Intersection Improvements to Gorham Street at the Lowell Connector Lowell, MA MassDOT Project No. 604694		
	Existing Conditions, Roundabout Basics, and Project Info	Response to Comments
1	How do trucks, busses, and other oversized vehicles navigate through the radius of the roundabout?	The roundabout will be designed to accommodate large and oversized vehicles. A mountable concrete apron will be included along the inside lane of the roundabout. Since the apron is mountable, an oversized vehicle will be able to drive over it to navigate the roundabout. Other vehicles (trucks and buses) will be able to navigate the roundabout in the same manner as a passenger car.
2	What is curb-to-curb width of Gorham?	Gorham Street varies in width from 32' to 35' curb-to-curb.
3	Is there precedent for vehicles not understanding a roundabout and jamming traffic this way?	Public education and outreach will be important leading up to the project's completion. Providing guidance to the public via multiple sources will reduce the instances of operator error.

SIGNALIZED INTERSECTION ALTERNATIVE
 LOWELL CONNECTOR ALTERNATIVE 2B
 GORHAM STREET ALTERNATIVE 12
 ELM / HIGHLAND STREETS ALTERNATIVE 23

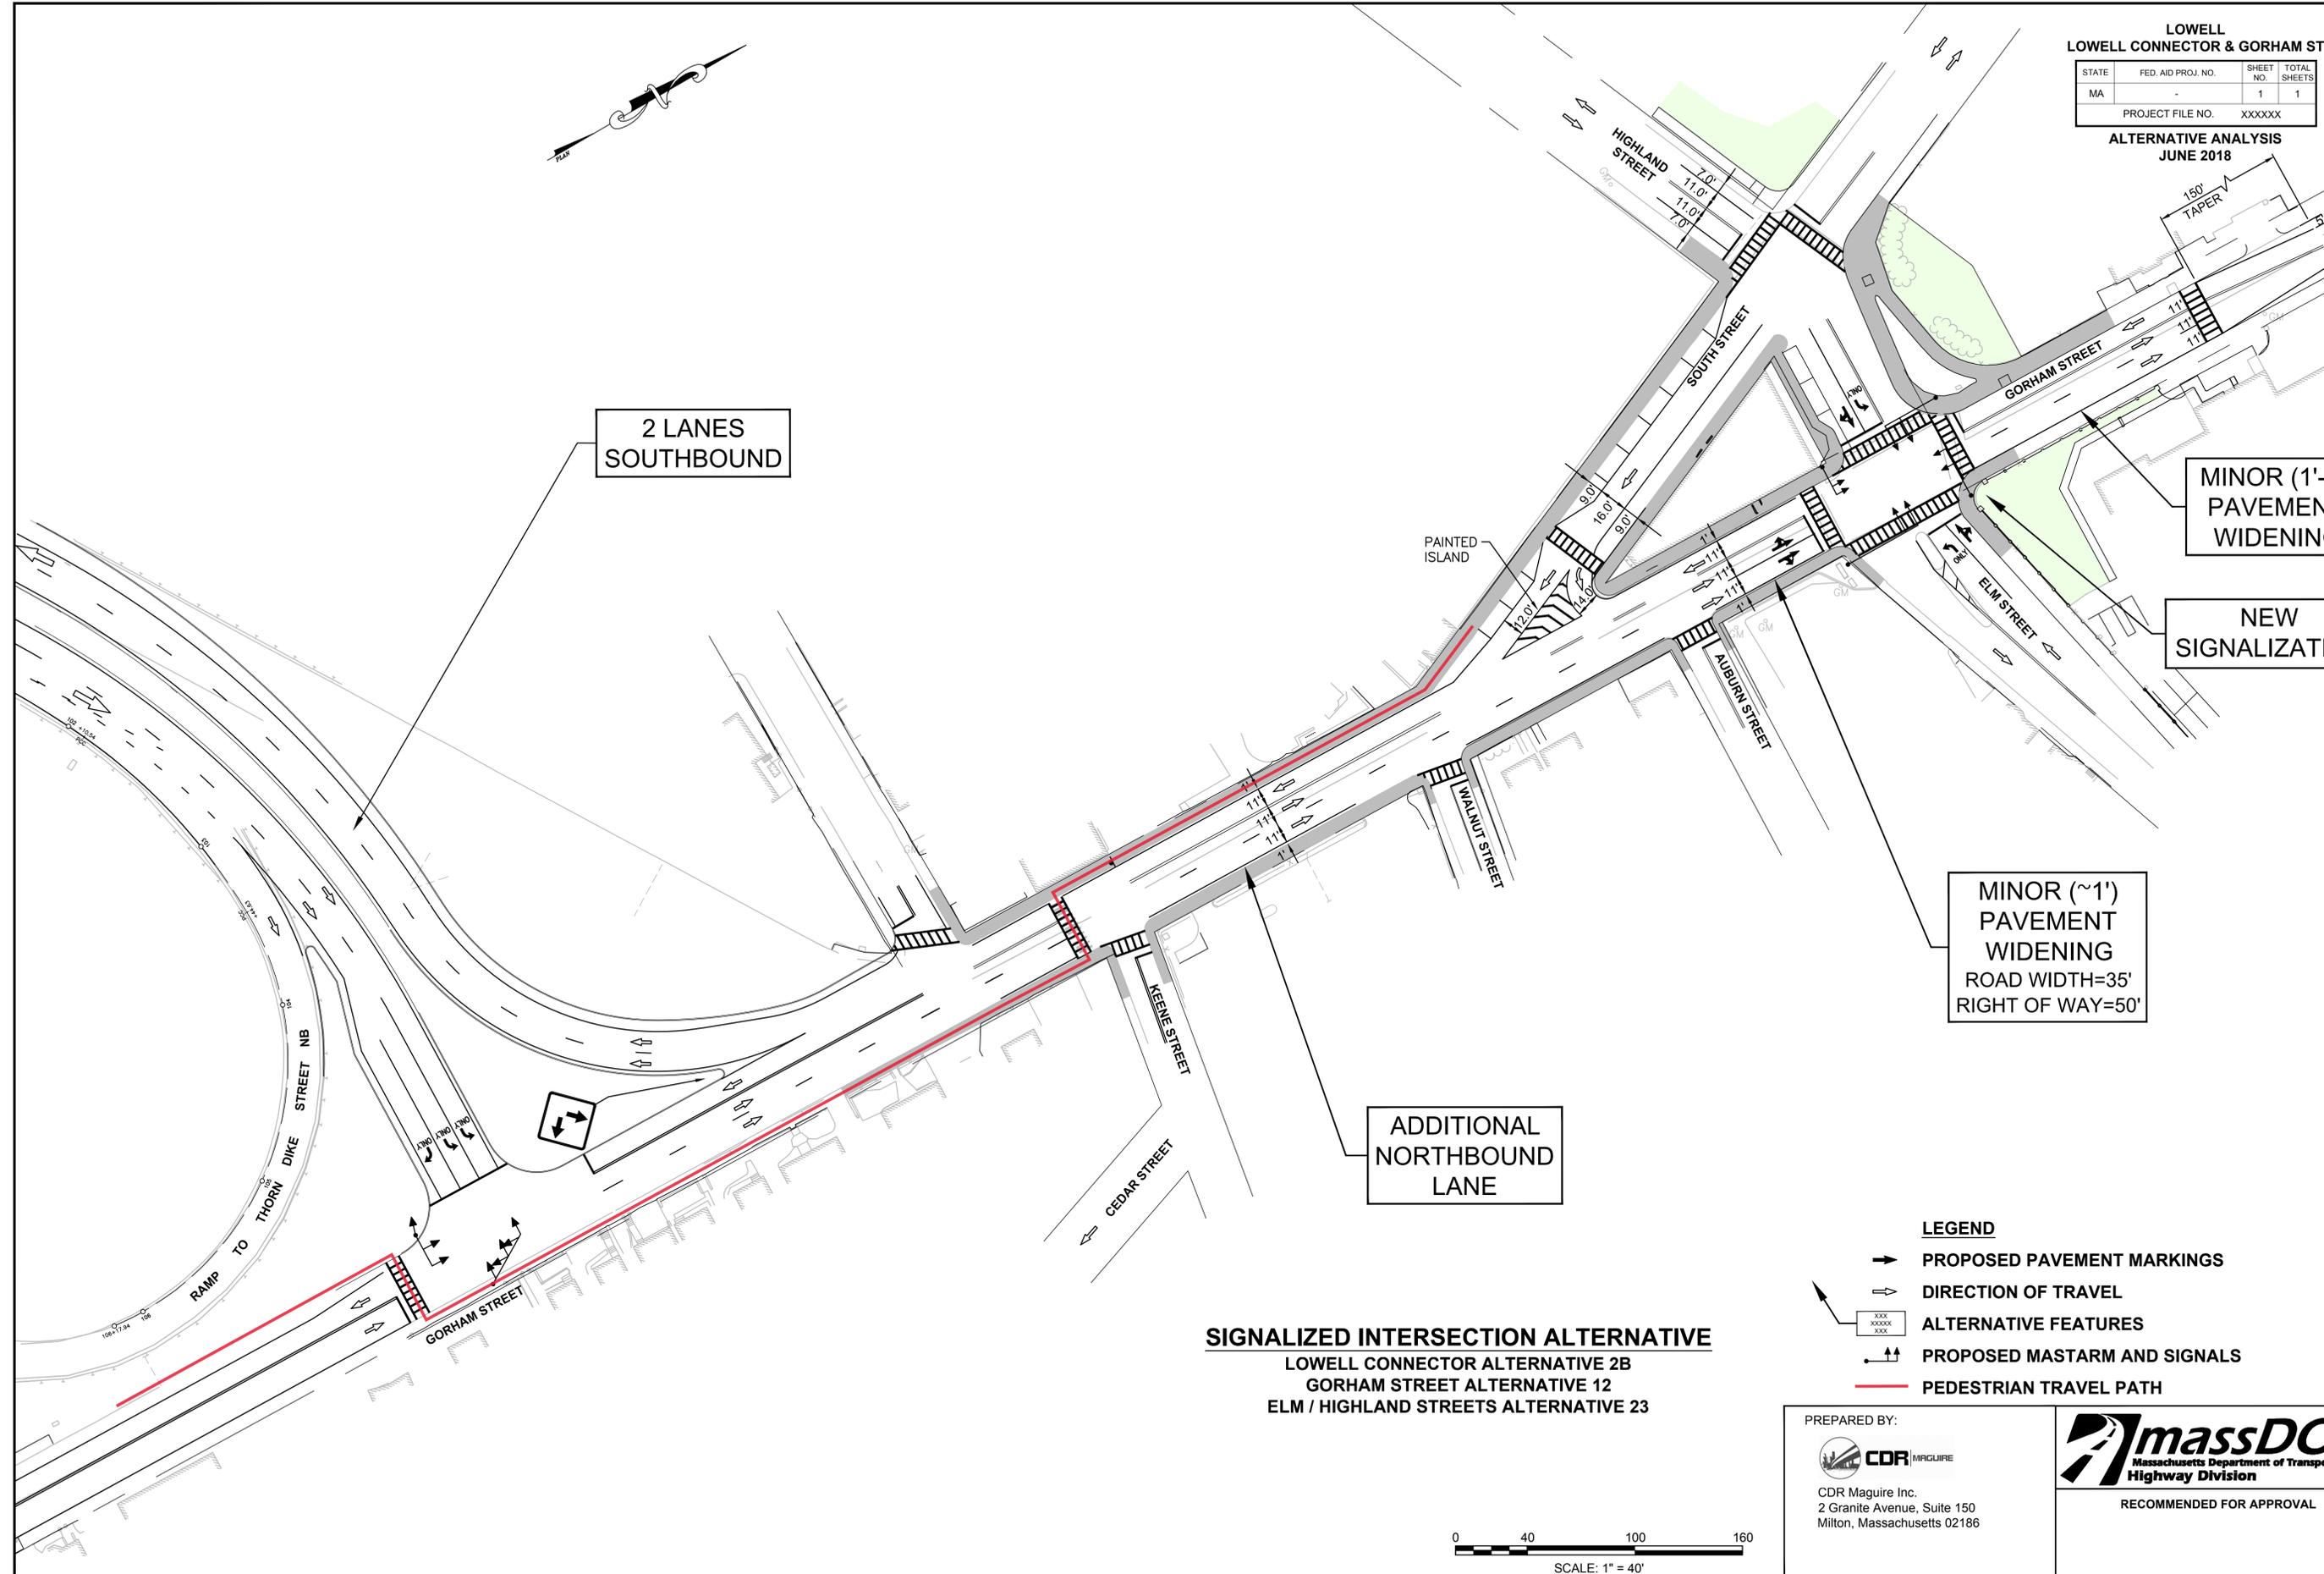
9	Does the plan require right-of-way takings, and do either alternative have different takings requirements?	Neither alternative will require right-of-way takings. All permanent features will be located within the State and City layout lines. Temporary construction easements will be required.
10	Please provide an overlay graphic of the existing condition (or satellite) and proposed alternatives	Graphics are attached to this response document.
